Council Reference: COM/91/2024
Attention: Patrick Thwaite

RE: Response to Information Request – Combined Application for Variation Request and Reconfiguring a Lot (2 into 33 Lots, New Roads and Drainage Reserve) at 67 and 69-75 Talinga Drive, Park Ridge

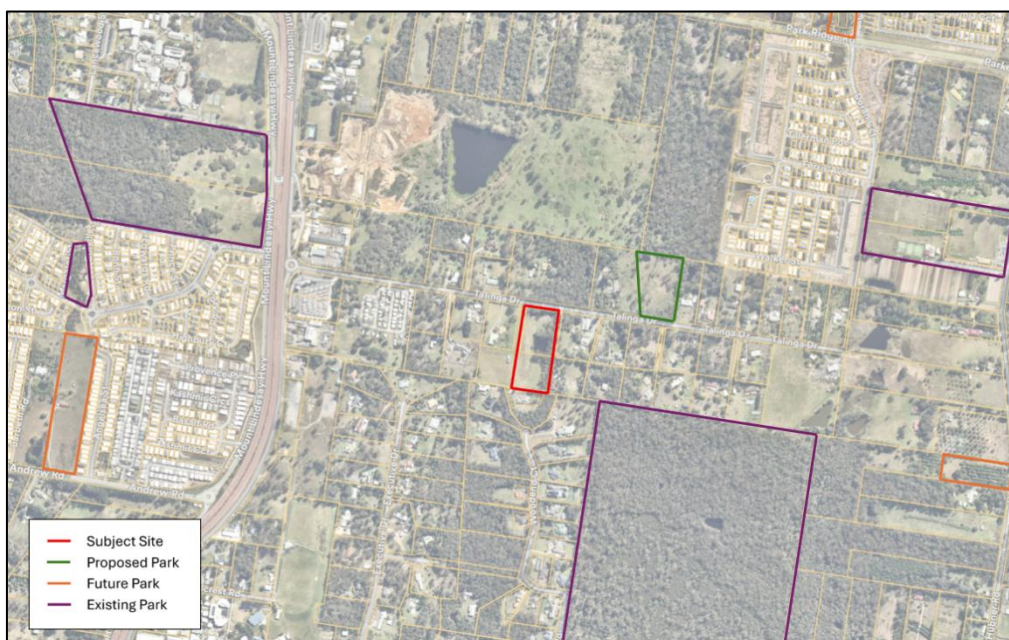
- 2.3. The proposed lots are located south of land which is proposed for environmental open space under COM/77/2023. The majority of the proposed lots are within a 400m walking distance of this mapped open space area, with a small number located approximately 500m walking distance. While the open space is not yet delivered and the application remains within its decision period, the subject development is functionally sequenced with that approval. Due to separate sewer servicing constraints, the proposed reconfiguration cannot proceed independently and will not be delivered prior to the completion of the adjacent development.

In the very unlikely event of the adjoining development not proceeding, the proposal remains characterised by a connected, low-traffic street network that supports walking for recreation, leisure and exercise. The proposed lot layout promotes safe pedestrian movement and direct connections to surrounding streets and the larger open space network, as shown below (based off LGIP v1.3, and including the adjacent development COM/77/2023).
